ADDENDUM NO. 1

**Bid #1461 Buildings L, T, W & X HVAC & Roof Replacement Project
at
Santa Ana College**

**Project ID #2957,
Buildings L, T, W & X- HVAC & Roof Replacements**

September 18, 2024

Laydown area for Buildings L, T, W X-Roof and HVAC Replacements

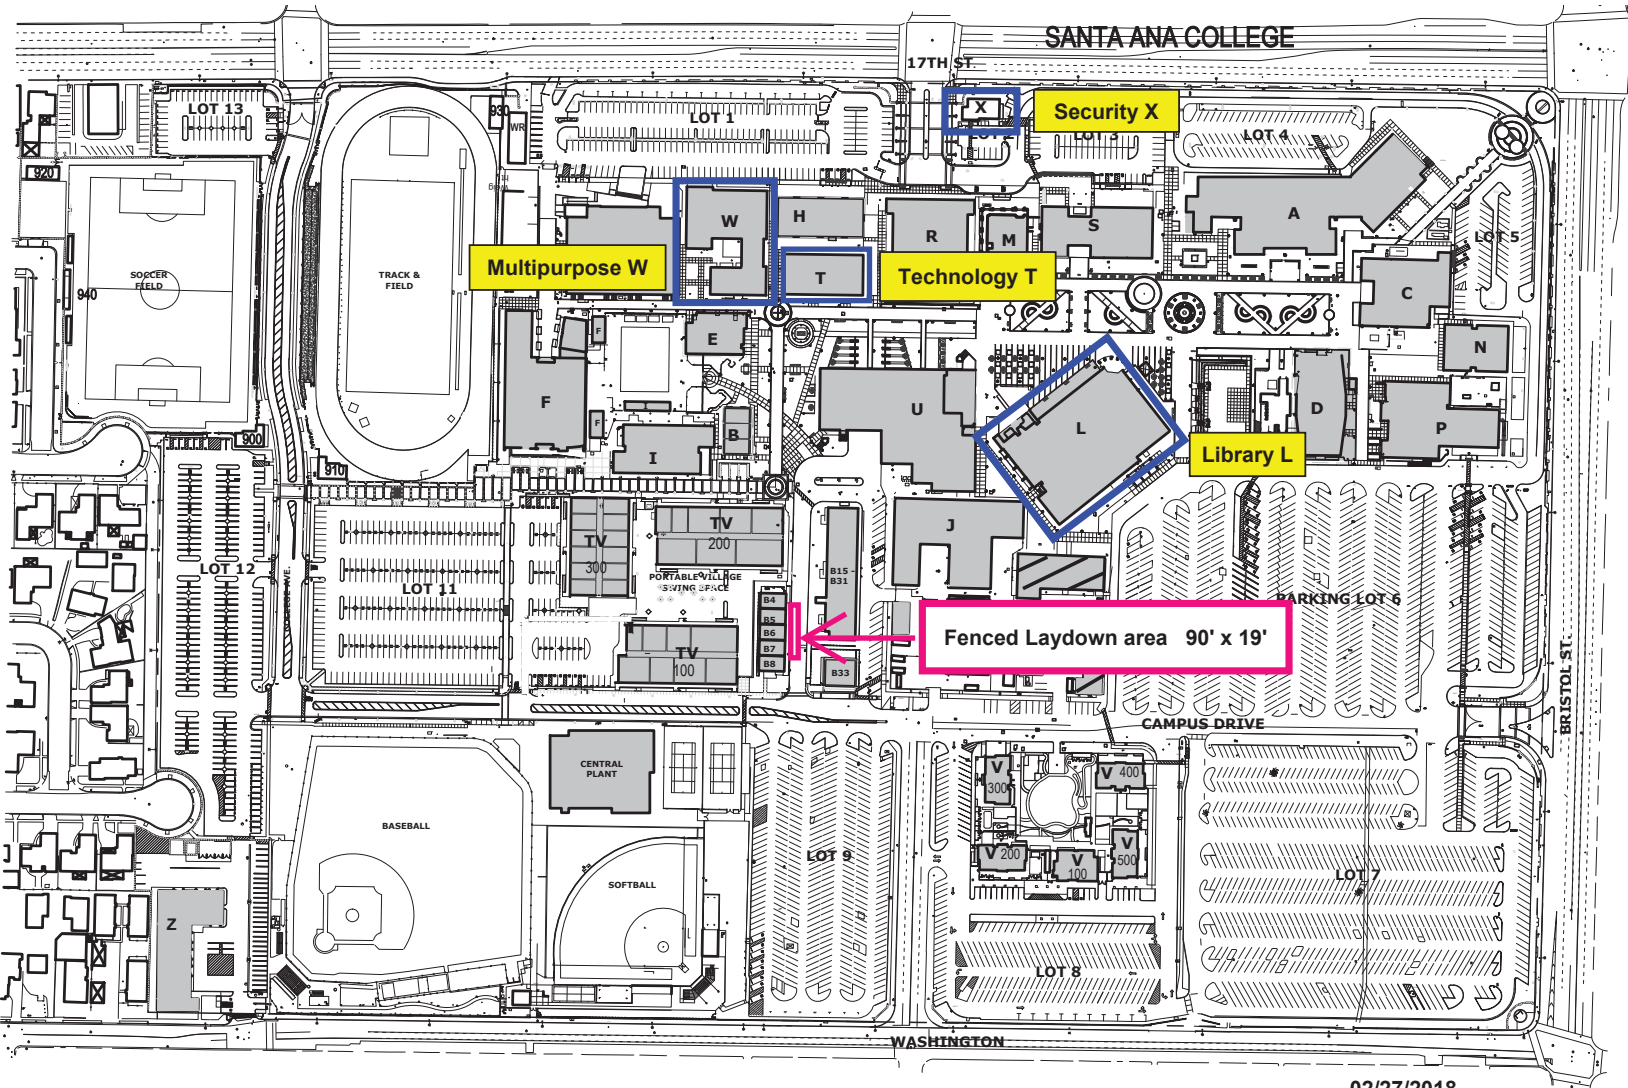
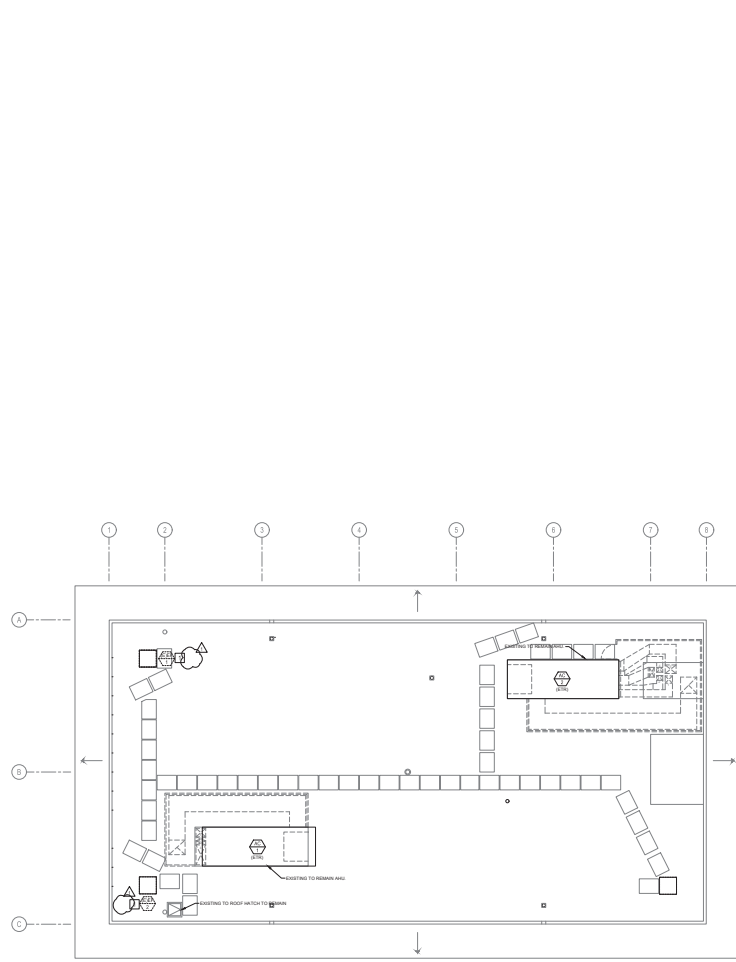
Please see attached revised Attachment D with an updated Staging and Logistics plan.

ED1.01

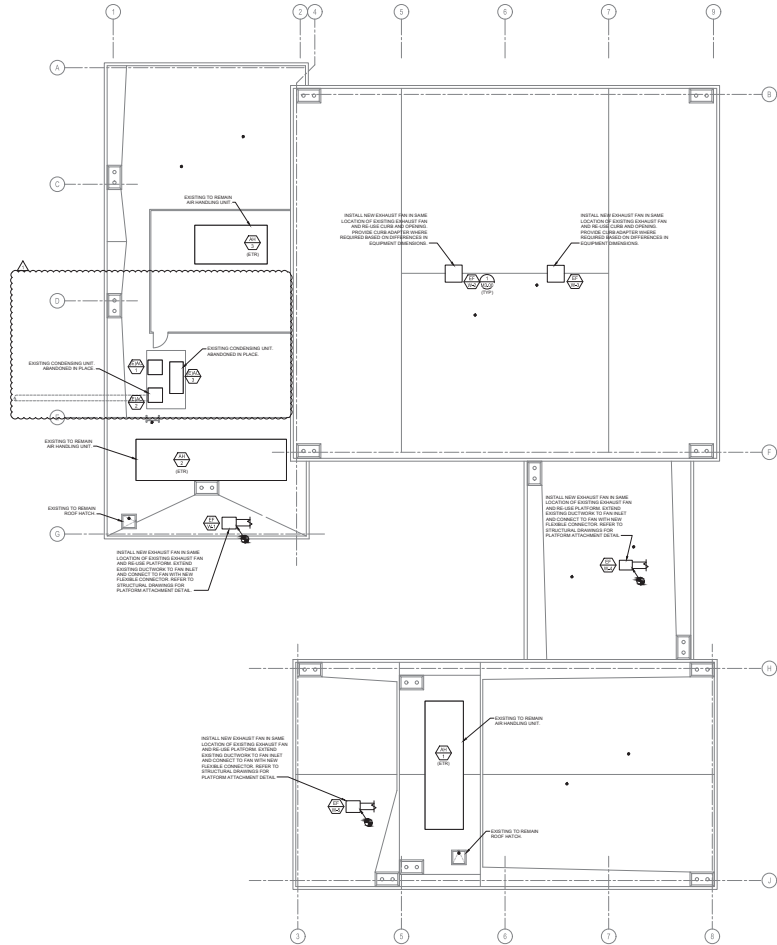
- On sheet M1.03, add keynote 1 to the page with an arrow head on RTU X-1.
- On sheet ED1.01, delete keynote 2 at EF1 and EF2.
- At spec section 230923-2.1-B, insert "4. Next Level Services. Contact Sandeep Dhillon. (213) 503-2022. sd@nextlevelems.com"

Sheet Number
M2.1 (R)
Of Sheets

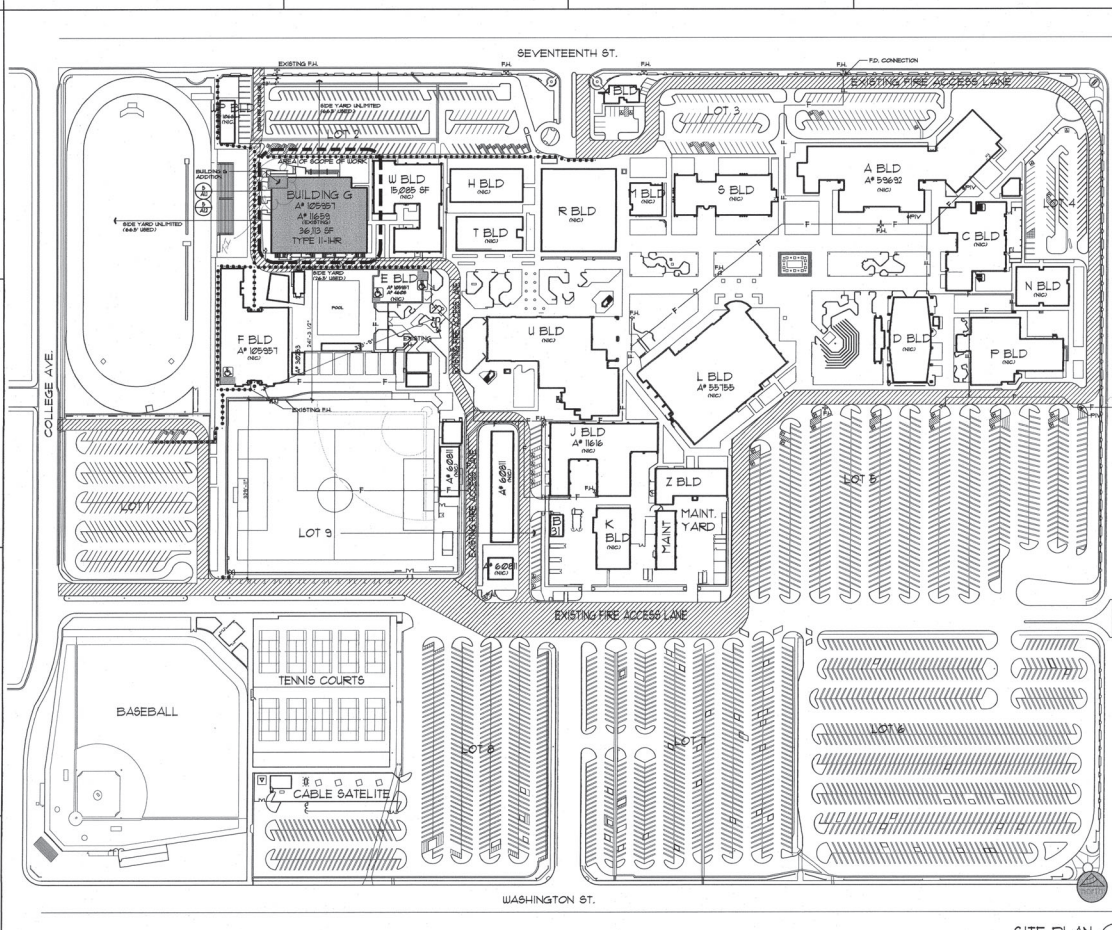
PROJECT NAME:	Bldgs L, T, W & X- HVAC & Roof Replacements Project at Santa Ana College		
PROJECT NUMBER:	2993 2957	BID NUMBER:	1461
EMAIL TO: facilitiesbid@rsccd.edu			
DATE:	09/10/24		
FROM:	Allison Mechanical Inc.	EMAIL:	office@allison1.net
SPEC SECTION:		DRAWING NUMBER:	
REQUESTED CLARIFICATION:			
Can you please give us a diagram of what concrete is fire rated? So we know where we can set up crane on campus			
RESPONSE TO CLARIFICATION:			
Please find attached District Record Drawing A1.OG.3 for reference. Answered by Pacific Rim Architects 09/17/24
